Office Action Summary

10/522,855

YAMAMOTO ET AL.

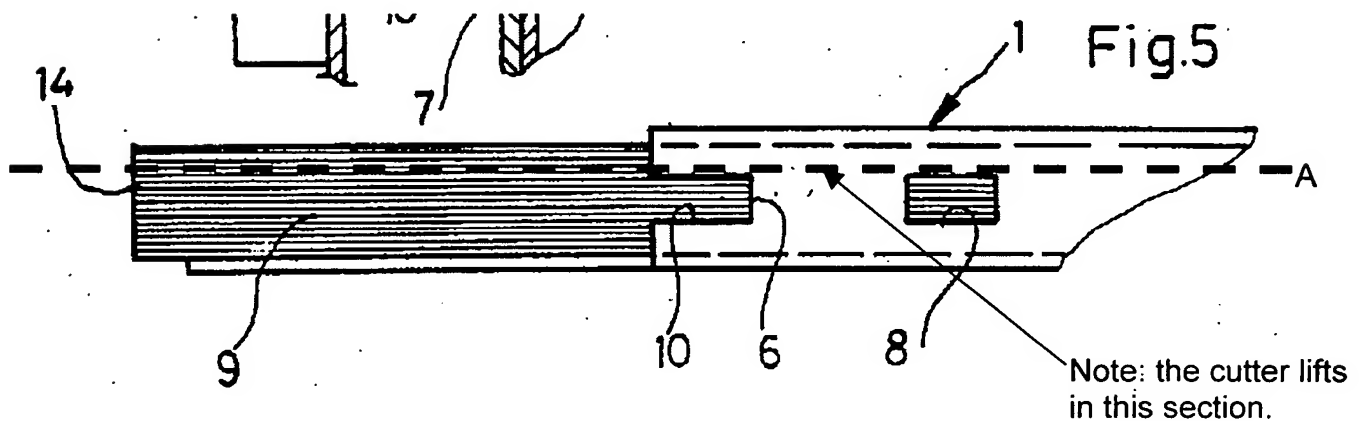
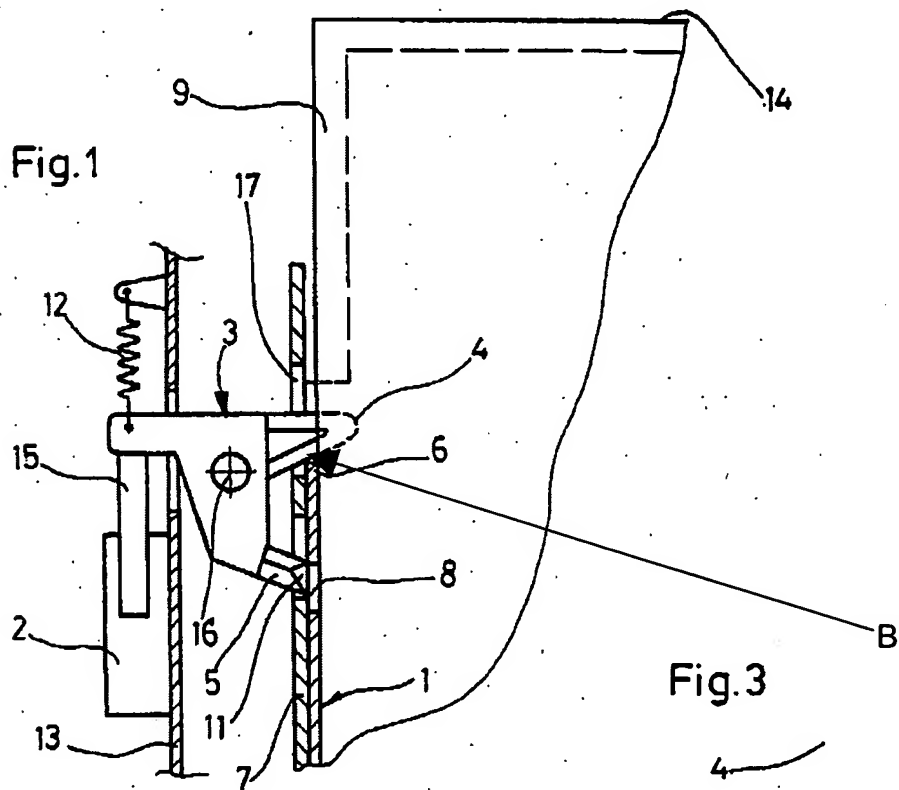
Claims 2 and 3: package member (1); perforated line (See Fig. 5 below, line A); side part into two parts (8 and 10 sections);

Claim 9: projecting part (3); level difference (See Fig. 1 below, B level; Note: B is "formed in" 7 since B passes through 7.); side wall of the sheet storage unit (7); side part (1 along which 6 is part);

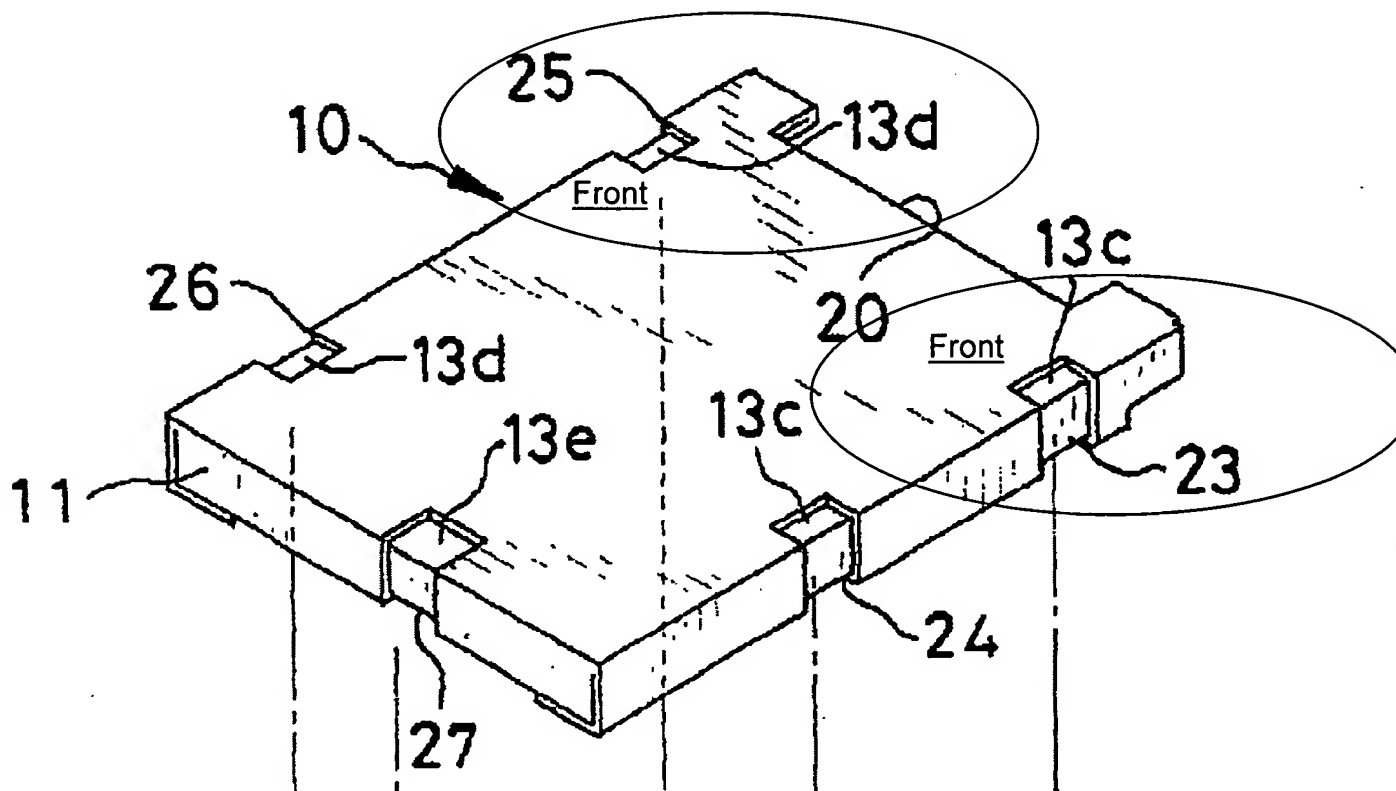
Claims 1 and 16-17: package member (10); sheet package (10); printer (abstract); side part (23 and 25); edge (23 and 25; See FIG. 6 below, note that the front sections are identified in regions.); sheet storage unit (40); projecting part (55); (Note: at *least one of the sides* of the sheets is capable of being in flush contact with the projecting member, especially as the user places the package into the storage unit.)

Claim 9: projecting part (55); level difference (See FIG. 6, 50 and 52); side wall of the sheet storage unit (55 at 40); side part (23 and 25);
